**SERVICE BULLETIN****SB20-01**

**SUBJECT:** Fuel Screen Assembly, Scheduled Maintenance**PURPOSE:** Augment current scheduled maintenance instructions**COMPLIANCE:** During the 100-Hour/Annual Inspection**MODELS****AFFECTED:** All Continental Aerospace Technologies new and rebuilt aviation gasoline (AvGas) engines equipped with throttle and control assemblies (reference Table 1).**I. GENERAL INFORMATION**

**Figure 1. Fuel Injection Control Assembly - Exploded View, typical**  
(Shroud, levers, and hoses removed for clarity)

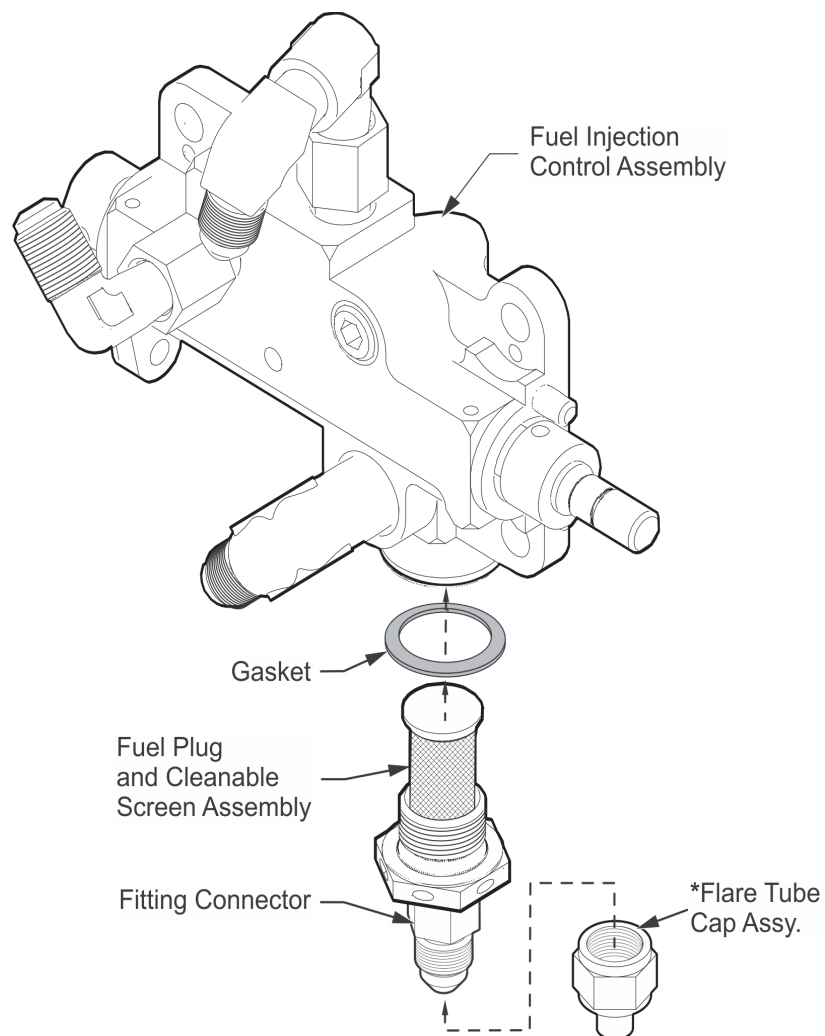
1. Cut, remove, and discard the safety wire from the fuel screen assembly.
2. Remove the fuel plug and screen assembly (with gasket) from the fuel injection control assembly housing; discard the gasket (see Figure 1). If equipped with a fitting connector and flare tube cap assembly, remove the flare tube cap assembly from the fuel plug and screen assembly (i.e. IO-520-D or IO-550-D). Inspect the fuel screen for damage.

- a. If the screen or plug threads exhibit damage, replace the fuel plug and screen assembly.
  - b. If the fuel plug and screen assembly appears to be serviceable, clean the fuel screen according to the instructions in M-0, Standard Practice Maintenance Manual, Table 12-1. Repeat the cleaning process until no debris remains in the screen.

- c. If the screen cannot be cleaned successfully, replace the fuel plug and screen assembly.
3. Apply anti-seize lubricant (P/N 646943) sparingly to the male threads of the fuel plug and screen assembly, ensuring the screen material does not become contaminated.

4. Install the fuel plug and screen assembly (with new gasket) into the fuel injection control assembly housing by hand. If a flare tube cap assembly was removed (reference step 2., above, (i.e. IO-520-D or IO-550-D)), install into the fuel plug and screen assembly according to the latest version of M-0, 3-3.1. General Sealant Application Instructions.

5. Torque the fuel plug and screen assembly (with new gasket and, if equipped with flare tube cap assembly) to 120 - 130 in-lbs according to the latest version of M-0, Appendix B.

6. Using new 0.032" safety wire; safety wire the fuel screen assembly to the anchor point on the fuel control assembly housing according to instructions in M-0, "Standard Practice Maintenance Manual, Table 3-8 (wire size), and Appendix C-3 (method).

**Figure 2. Affected Throttle and Control Assembly, typical**

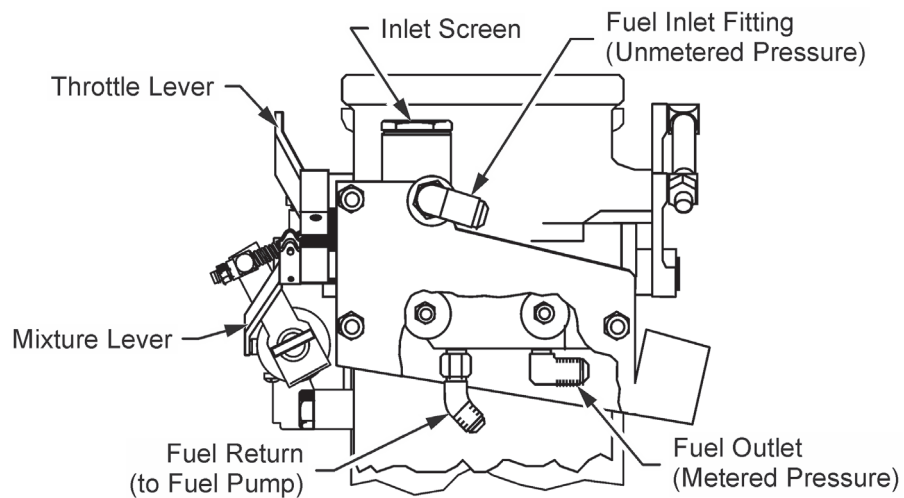
Continental engines equipped with a throttle and control assembly (see Figure 2 on page 4) use a fuel screen assembly and are affected by this service document. Continental engines equipped with a metering assembly that is integral to the air throttle body (see Figure 3 on page 4) **do not** use a fuel screen and are not affected by this service document. In addition, these assemblies may have multiple part numbers due to configuration, however they may be identified by the rectangular base body that is distinctly separate from the air throttle body.
